# Service Information

Category <b>E</b>	<b>Repair Guidance</b>	Ref. No. R008/09 <b>A</b>	Page 1 of 2
Coverage <input type="checkbox"/> Distributor only <input checked="" type="checkbox"/> Please inform your dealers		Date Issued February 3, 2009	
Please convey this information to your <input type="checkbox"/> Director <input checked="" type="checkbox"/> General Manager <input checked="" type="checkbox"/> Warranty Dept. <input checked="" type="checkbox"/> Parts Dept. <input checked="" type="checkbox"/> Training Dept. <input checked="" type="checkbox"/> Field Rep.		Date Revised May 12, 2010	
Applicable Model  RX-8 (FE / SE)		Applicable Countries or Specifications  Worldwide

## Subject: Coolant Warning Light Comes ON

### MASS PRODUCTION CHANGE

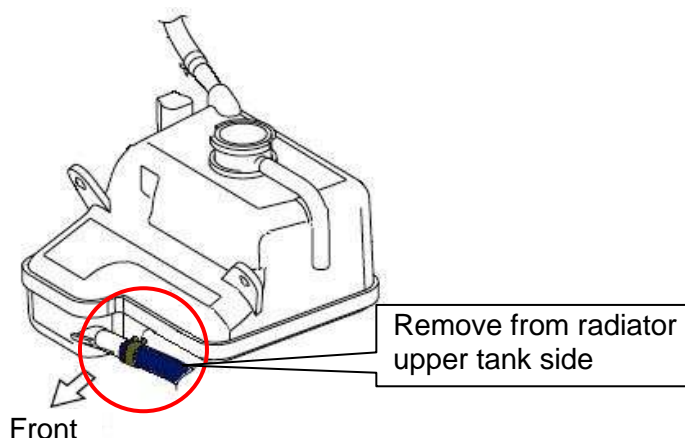
The specification of coolant level sensor float has been changed.  
(Replacement part differs depends on design level of the coolant level sensor.)

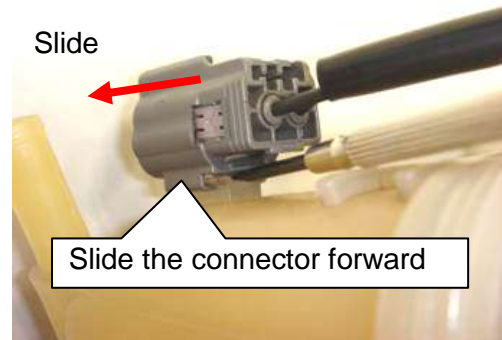
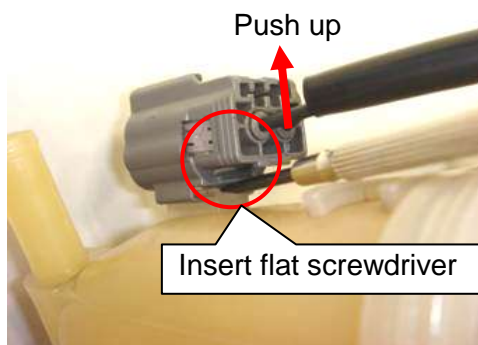
2. Replace the necessary parts according to the VIN range as shown below.

Replace the "tank with sensor"

Replace the "tank only"

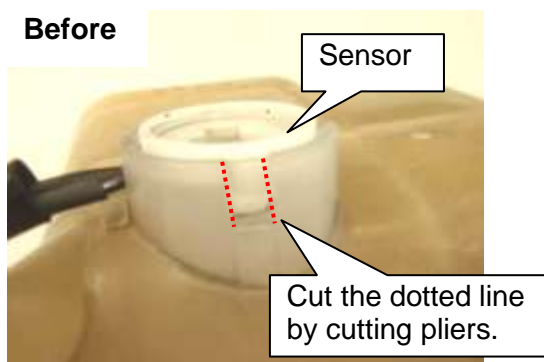
- (2) To remove the sensor connector from the tank, insert a flat screwdriver underneath the connector and push up. Then slide the connector forward.

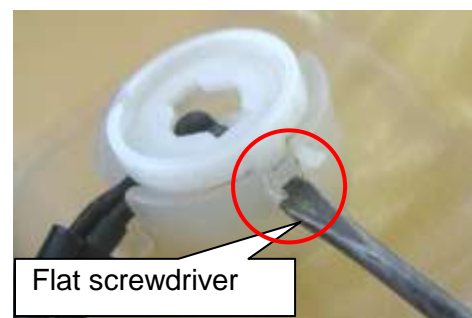
- (3) To remove the sensor from the coolant reserve tank, cut the dotted line as shown below (both sides) by using cutting pliers.
